# ***Erskine Park Waste & Resource Management Facility***

State Significant  
Development  
Modification Assessment  
(SSD 7075 MOD 3)

October 2018

**Figure 4 | Proposed Modifications to Stage 1 WTS**

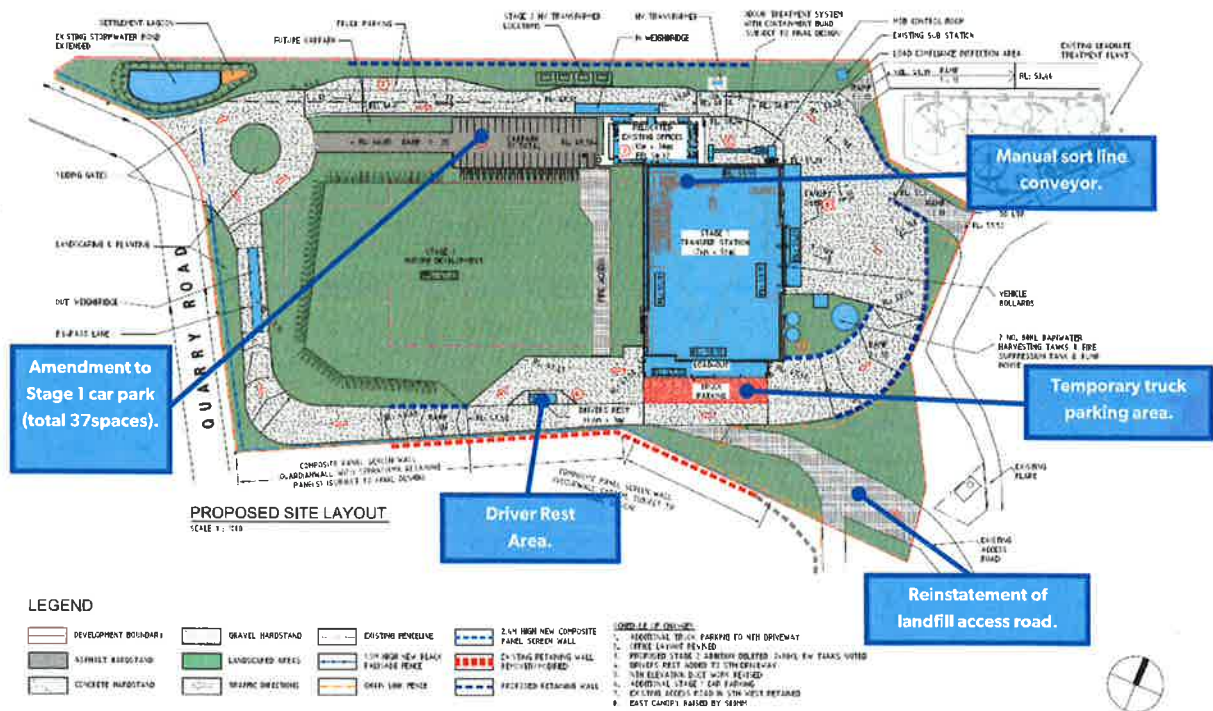
- the implementation of a manual sorting line within the Stage 1 WTS requiring an additional fifteen (15) employees for operation
- increase of car parking provisions to facilitate additional employment numbers associated with the manual sorting line
- inclusion of a truck parking area to the north of the site
- inclusion of a driver rest area in the southern driveway
- temporary truck parking area
- reinstatement of south-east landfill access road
- minor external design changes.
